New England Highway bypass of Singleton

Submissions report

Transport for NSW | August 2020

FIG. 1-3 The southern connection

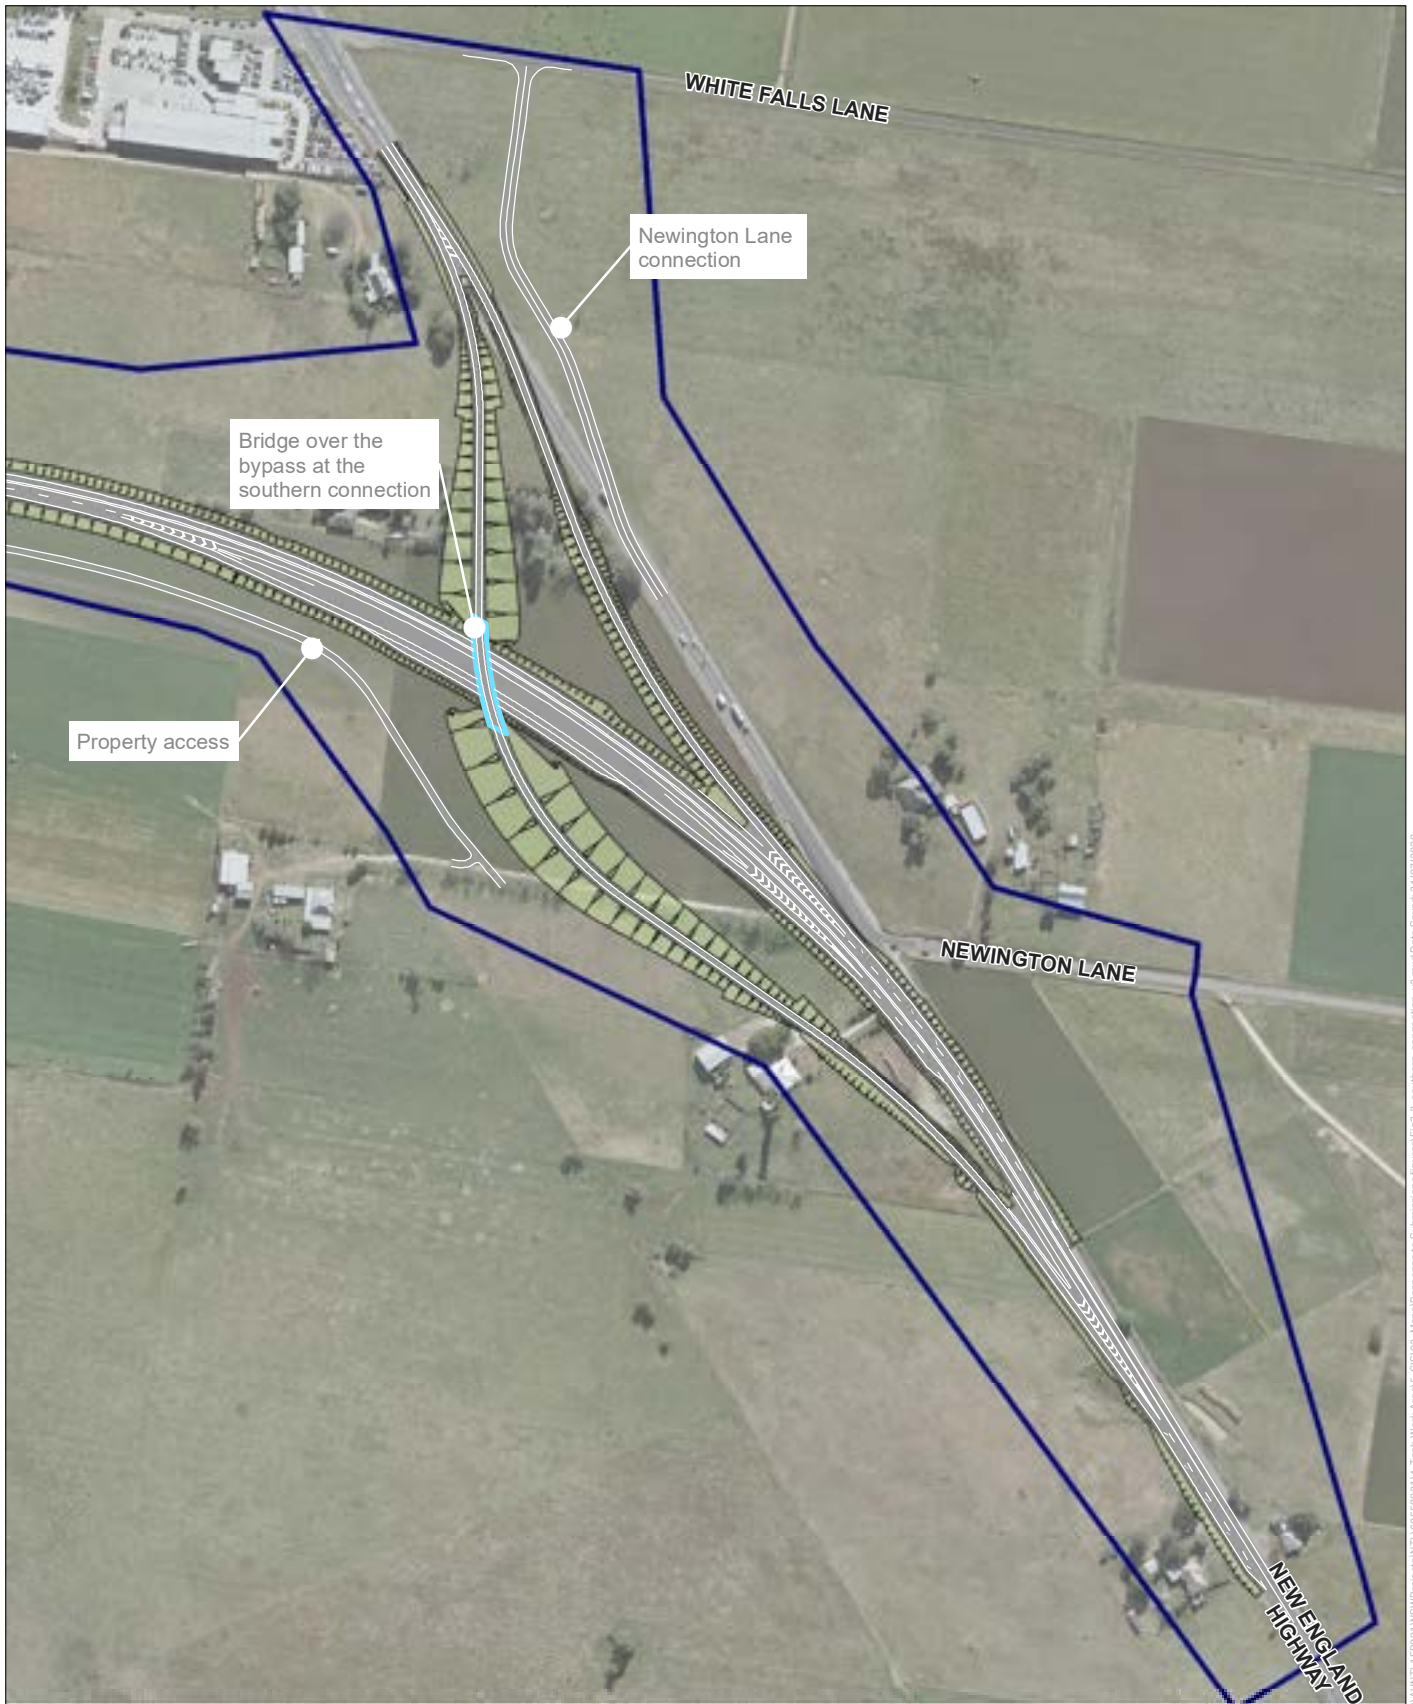
No.	Location	Drawing/ Document No.	Issue	Response
1	Newington Lane	Figure 3.2	<p>There is a lack of detail regarding the treatment of the existing Newington Lane and New England Highway (NEH) intersection. Will this be fenced and /or landscaped to prevent vehicles taking short cuts onto / from Bypass?</p> <p>Council requests further information in regards to this element of the design.</p>	Both a barrier and the level difference between lanes at this location would prevent this movement.
2	REF – Section 3.22 Engineering Constraints	Table 3-2 Design Criteria	<p>Design criteria for ancillary roads / existing NEH works have not been provided.</p> <p>Council requests further Information in regards to this element of the design.</p>	Refer to general response at the start of Section 3.2.
3	REF – Section 3.22 Engineering Constraints	Table 3-2 Design Criteria	<p><i>Posted speed New England Highway:</i> <i>100km/h</i></p> <p>The design speed not provided, typically design speed is 10kph higher than posted speed. 100kph posted speed is consistent with existing posted speed south of Bypass. Northern end of Bypass connects to NEH in an 80kph speed zone.</p> <p>Council requests clarification as to the design speed.</p>	<p>The posted speed on the bypass would be 100 kilometres per hour. The design speed is typically 10 kilometres an hour higher than the posted speed.</p> <p>The 80 kilometre per hour speed limit at Rixs Creek would not change for the proposal.</p>

FIG. 1-6 Connection to the New England Highway at Gowrie Gates

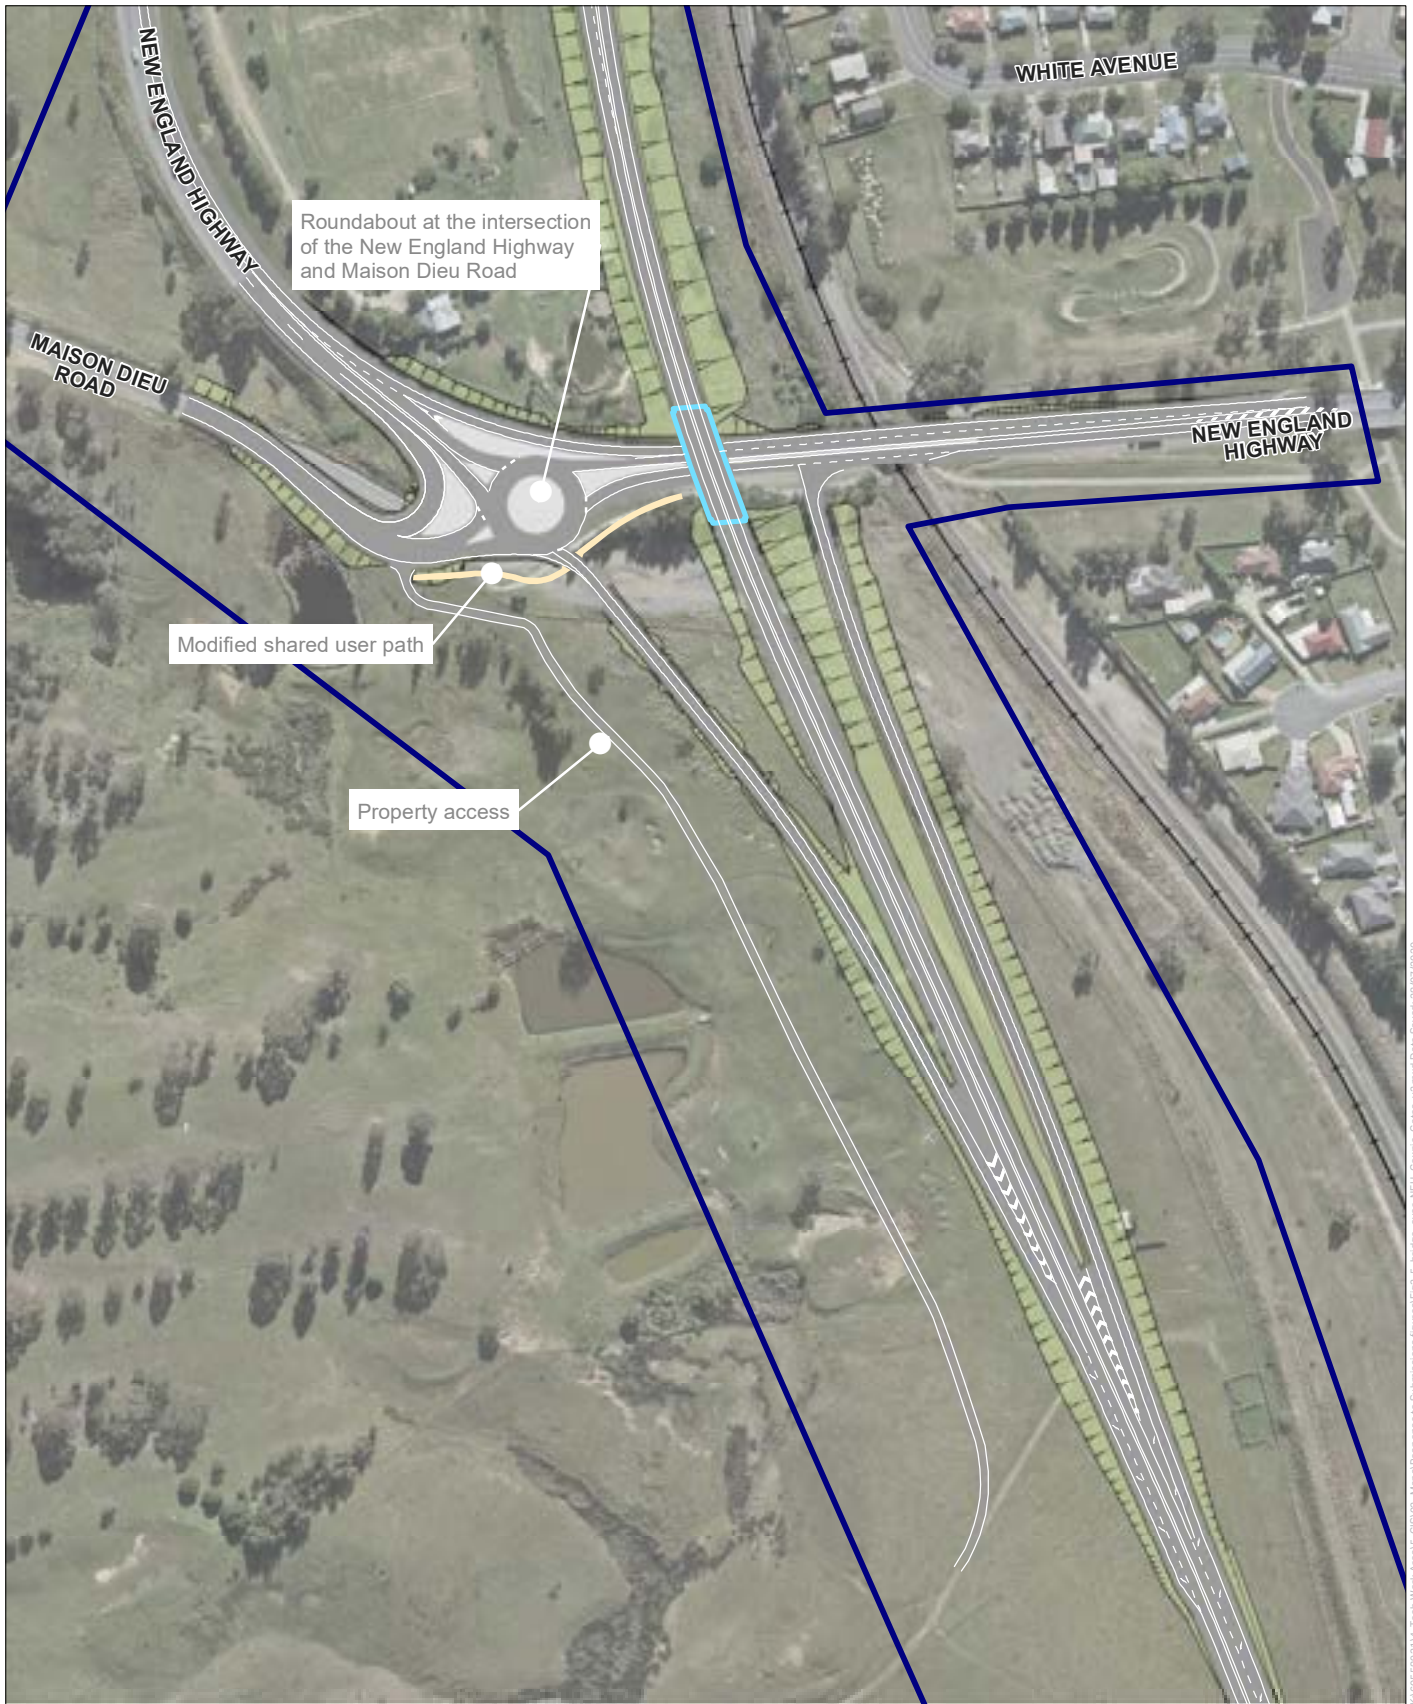
No.	Location	Drawing/ Document No.	Issue	Response
16	Interchange B	Dec '19 Project Update document page 3.	<p>The eastern leg of the proposed new roundabout at the intersection of Maison Dieu Road and New England Highway develops into dual east bound lanes into Singleton, merging into a single lane before the Simpson Terrace intersection. The recently completed Gowrie Gates formation under the rail line is a single lane each way with shoulders. The proposed design significantly reduces the shoulder adjacent to the northern rail bridge abutment. Clear zones will need to be assessed for compliance. This will also make access to the ARTC access layback difficult due to slowing down in the through lanes to cross the layback accessing the rail corridor.</p> <p>Council requests that TfNSW clarifies that clear zones will be compliant and that access the ARTC layback has been considered.</p>	Refer to general response at the start of Section 3.2

FIG. 1-7 The northern connection

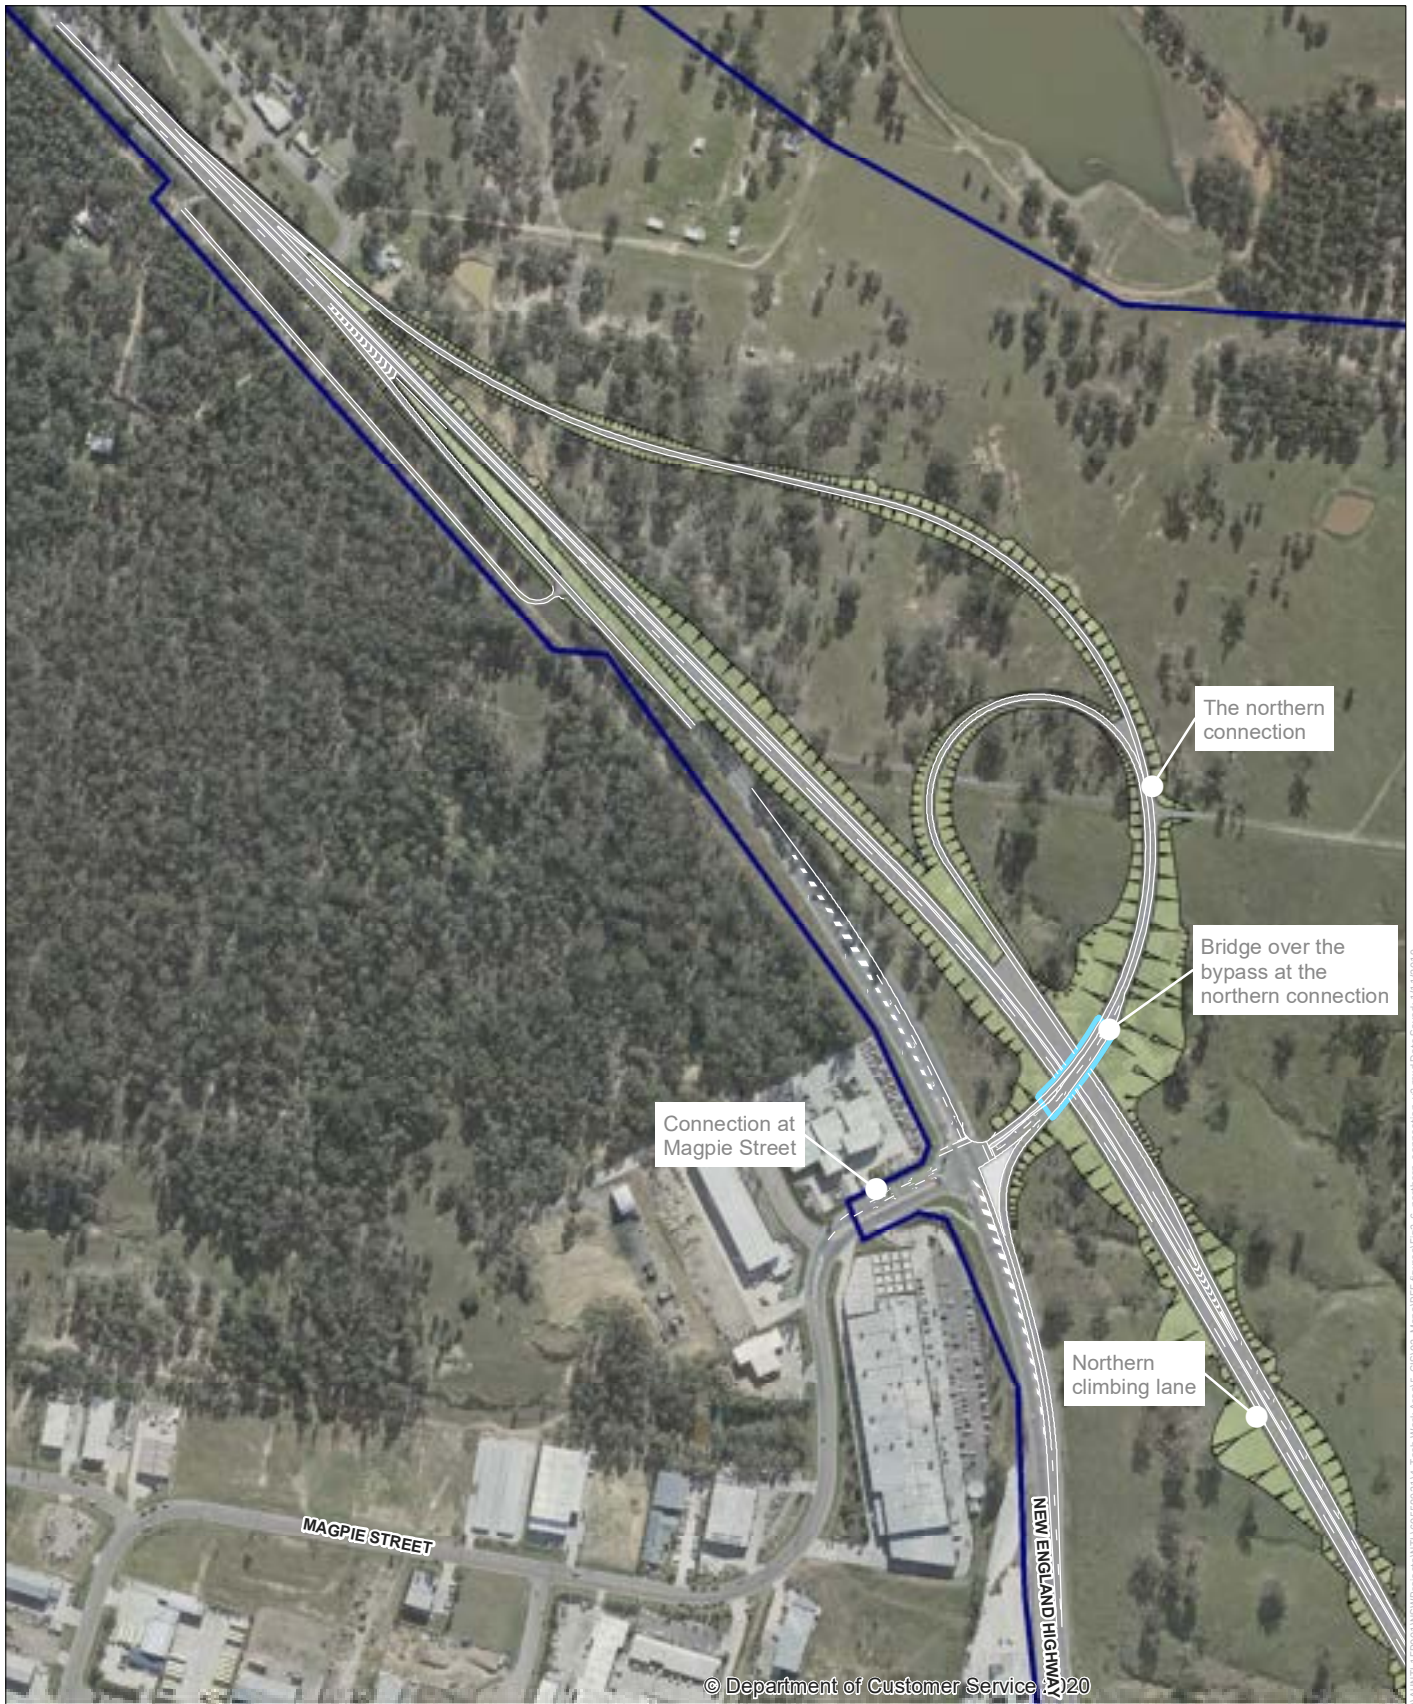
12	Northern Connection	Figure 3.6	<p>The right turn lane access to the rest area and the adjacent property are not catered for in the design. Both properties are subject to partial acquisition with restoration of full access.</p> <p>Council requests the TfNSW confirm if the right turn lane access to the rest area and</p>	The right turn access arrangement at this location would not change for the proposal.

No.	Location	Drawing/ Document No.	Issue	Response
			the adjacent property are to be catered for in the design?	
13	Northern Connection	Figure 3.6	<p>The length of the northbound merge lane, circa 220m, appears to be too short for merging to a 100km posted speed.</p> <p>Council requests that TfNSW confirms that the northbound merge lane at the northern connection meets current design guidelines for a 100km posted speed.</p>	<p>Refer to general response at the start of Section 3.2.</p> <p>The merge lane is an appropriate length.</p>
14	Northern Connection	Figure 3.6	<p>Access to the vehicle inspection area does not appear possible from the northbound lane of the bypass as it crosses the northbound merge lane from the existing NEH.</p> <p>Council requests that TfNSW clarify if the northbound merge lane at the northern connection meets current design guidelines for a 100km posted speed.</p>	<p>The vehicle inspection area would be relocated to the southern connection.</p>

15	The Northern Connection	Figure 3.6	<p>No provision for on-road cyclists is made for at eastern leg of intersection, allowing residents from the east cycle access to commercial area. Existing signalised intersection makes provision for north south cycle access.</p> <p>Council requests that TfNSW clarify if provision will be made for on-road cyclists is made for at eastern leg of intersection.</p>	<p>The shoulders would be sealed and generally be three metres (or 2.5 metres on the bridge over the floodplain) which would be suitable for on-road cyclists.</p>
